DEPARTMENT OF TRANSPORTATION

Federal Aviation Administration

[Docket No. NM-26; Special Conditions No. 25-ANM-23]

Special Conditions: Airbus Industrie Model A320 Series Airplane

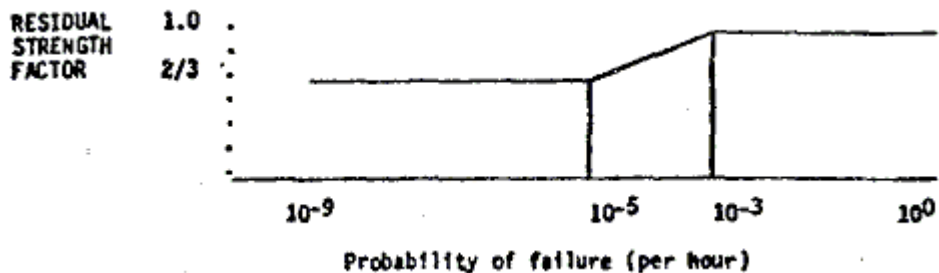
*Paragraph 2(a)(2)(ii)(B)(1)(i).* Two commenters state that in the figure the safety factor should be 1.5 for probability of failure equal to or less than  $10^{-3}$  to agree with the text. FAA concurs and the final special condition is revised to correct this error.

(i) For the static strength substantiation, each part of the structure affected by failure of the EFCS must be able to withstand the above specified loads multiplied by a factor between 1 and 1.5 depending on the probability of the failure conditions. The factors shown in the following figure may be used.

(ii) For structure affected by failure of the EFCS and with structural damage in combination with the EFCS failure conditions, a factor must be applied for the same purpose to the loads used for the justification of the airplane without system failure condition. In any case, the residual strength level must be at least 2/3 of the gust or maneuver conditions, combined with the normal operating cabin differential pressure (including the expected external aerodynamic pressures), specified in § 25.571(b) of the FAR. The residual strength factors shown in the following figure may be used.
